Our Case Number: ABP-321937-25

Re: This proposed development is for flood defences at key locations along the Carrickmines and Shanganagh rivers including new walls/raised existing walls, culverts, localised screens upgrades and localised works in the river. An Environmental Impact Assessment Report (EIAR) is submitted with application
This proposed Flood Relief Scheme for the Carrickmines-Shanganagh Rivers at sites in the townlands of Woodside, Kilgobbin, Carrickmines, Brennanstown, Shankill, Loughlinstown, Shanganagh and Hackettsland

RE: FLOOD RELIEF SCHEME FOR THE CARRICKMINES AND SHANGANAGH RIVERS
Your Ref. No. ABP JA06D.321937

Figure 9: Section 1-1 Extract JBA Consulting DRWG. No. DR-Z-02932 RevC01

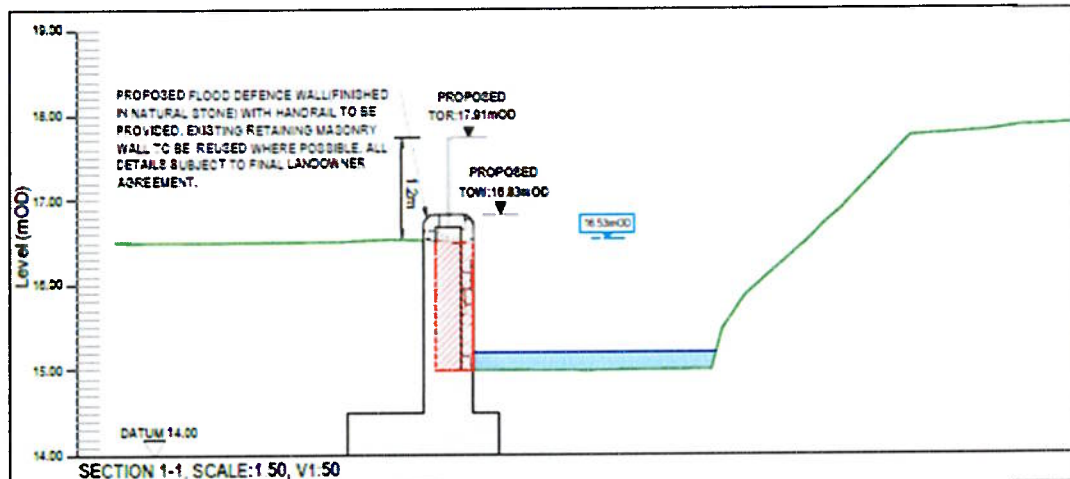
2.7 Section 1-1 in Figure 9 shows that the proposed works entail the removal of the existing granite wall to the west bank of the river (shaded red) and the construction of a reinforced concrete retaining wall.

2.8 I question the accuracy of the ground levels on the east side of the river shown in Section 1-1. The ground levels on the east side of the river are generally lower than on the west side at this location, yet the levels are shown higher in this section (see Figure 4).

Figure 10: Extract Proposed Site Layout JBA Consulting DRWG. No. DR-Z-02930 RevC01

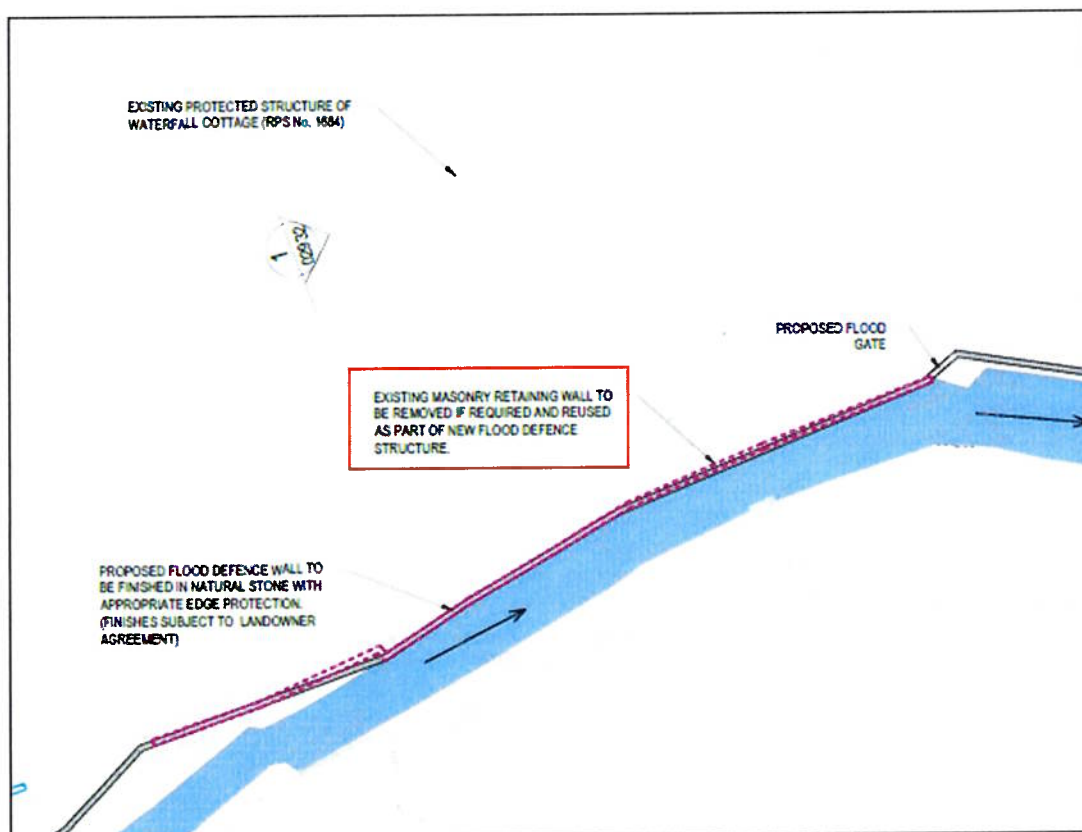
- 2.9 Figure 10 is an extract from the proposed site layout in the vicinity of Waterfall Cottage. I have highlighted in red the drawing note pertaining to the works along this portion of the flood defence, which is immediately at the rear of the house close to Section 1-1 (Figure 9). The drawing note suggests that the existing wall to be removed "if required," which is not consistent with the details shown on Section 1-1 where the existing wall is explicitly to be removed (shaded red on Section 1-1).
- 2.10 The proposed site layout indicates a new flood defence wall set back from the edge of the river extending from the flood gate at approx. CH 67 to the N11 culvert at approx. CH 129. Section 2-2 is located within the curtilage of Waterfall Cottage just south of Rose Cottage. The proposed flood defence at Section 2-2 is shown in Figure 11.

Figure 11: Section 2-2 Extract JBA Consulting DRWG. No. DR-Z-02932 RevC01

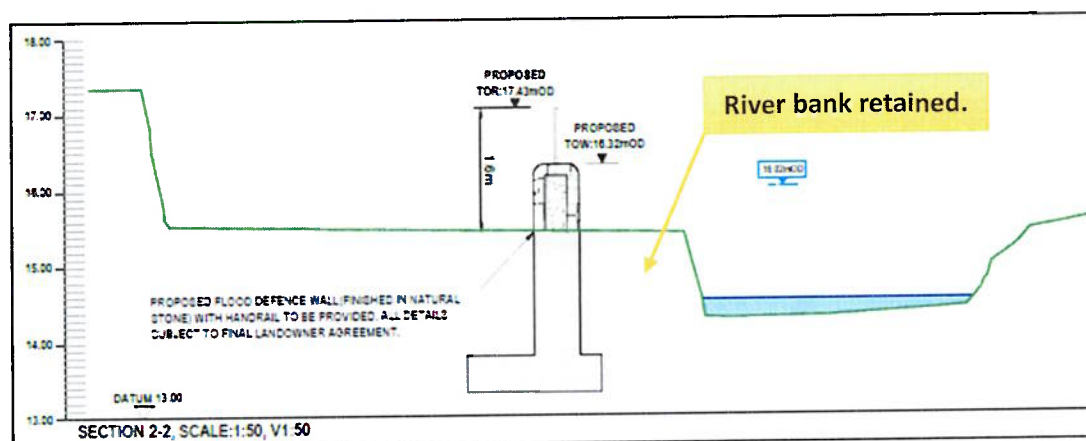
- 2.11 Section 2-2 indicates that a reinforced concrete retaining wall will be built to a height of 16.32m OD with a railing over and shows that the ground between the edge of the river and the flood defence wall will be retained. This may indeed be the proposal and it aligns with the proposed site layout, which also shows a strip of land between the river and the proposed flood defence. However, the existing granite wall is not shown in the section or in plan, and the removal of the existing wall is not referenced on Section 2-2.

- 2.12 The proposed site layout only shows the new wall in this location and it does not indicate that the existing wall lining the river is to be removed (depicted by red hatching in the legend on the site layout drawing), yet the existing stone wall lining the river at this location is omitted from Section 2-2. Thus, the works shown on the proposed site layout and on the section are silent about the status of the existing wall. Where the information provided is so limited, and yet it is inconsistent as regards such fundamental details, the Board will appreciate our client's lack of confidence in relation to the delivery of this project and the implications at our client's properties.

Figure 12: Section 5-5 Extract JBA Consulting DRWG. No. DR-Z-02932 RevC01

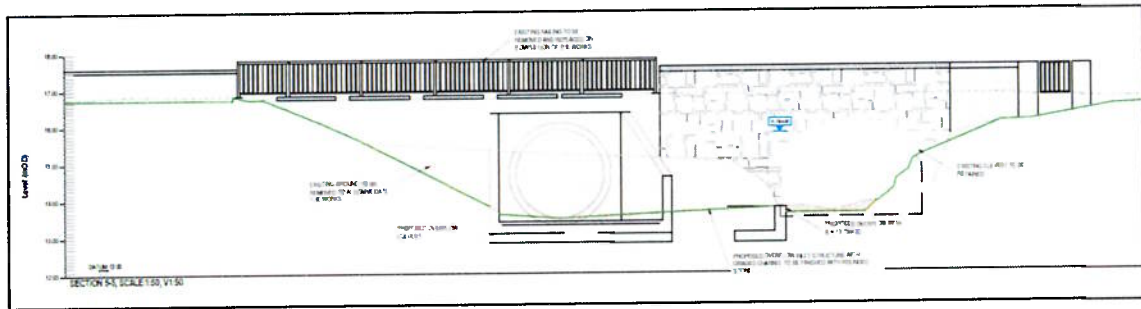
- 2.13 Figure 12 is a section through the proposed overflow culvert between Rose Cottage and the N11 bridge. The existing culvert is faced with cut stone, which considerably enhances the visual aesthetic of the bridge. A few questions occur in relation to these works.

- 2.16 Section 5-5 does not indicate that the proposed culvert will be finished in stone and it is inferred from the drawing that the structure will be made of and finished in concrete. If this is the case, our client considers the proposed works do not have adequate regard to the character of the existing culvert and to the location of the site within the curtilage of a protected structure.

- 2.17 The construction of the inlet to the overflow culvert will involve significant excavation work and soil removal as shown on Section 5-5. The flood defence wall measures approx. 129m long extending from the inlet at Rose Cottage to a point past Cherrywood Cottage, virtually all of it within our client’s ownership. Sections through the reinforced concrete retaining wall show that the total height of this new flood defence ranges from 2.83m (Section 1-1, i.e. 16.83m OD – 14.00mOD) up to 3.32m (Sections 2-2/3-3 and 4-4) so it is a substantial structure, the construction of which will entail heavy duty engineering works in proximity to our client’s home. The consideration of alternatives does not include the retention of the existing stone wall and raising the wall height above the 1% AEP flood level. If feasible, this would reduce the construction works at our client’s home.

Figure 14.16: Photomontage 4, proposed view at Waterfall Cottage

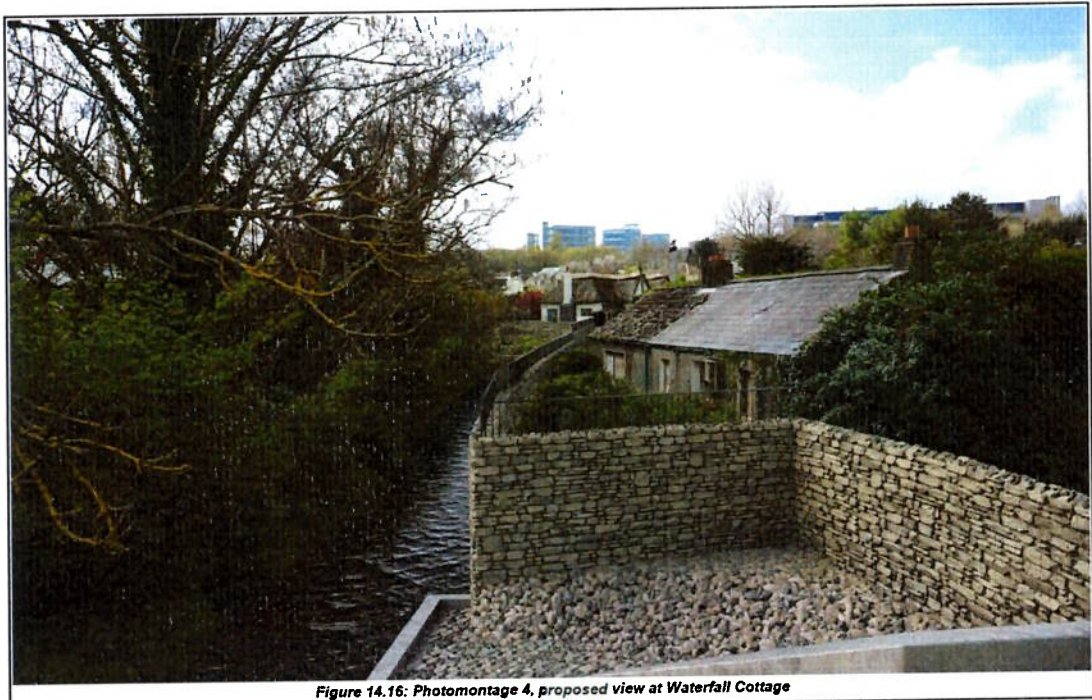
- 3.39 EIAR Figure 14.16 above purports to show the visual impact of the flood defence works upon Waterfall Cottage (this figure is a replica of Figure 13.37 referenced at paras. 3.24 and 3.30. Figure 14.16 merely shows the permanent negative impact at Rose Cottage. By virtue of the distance to Waterfall Cottage, the angle at which the original photograph was taken and the intervening vegetation, Figure 14.16 is of virtually no assistance in terms of assessing the visual impact of the proposed works at Waterfall Cottage.
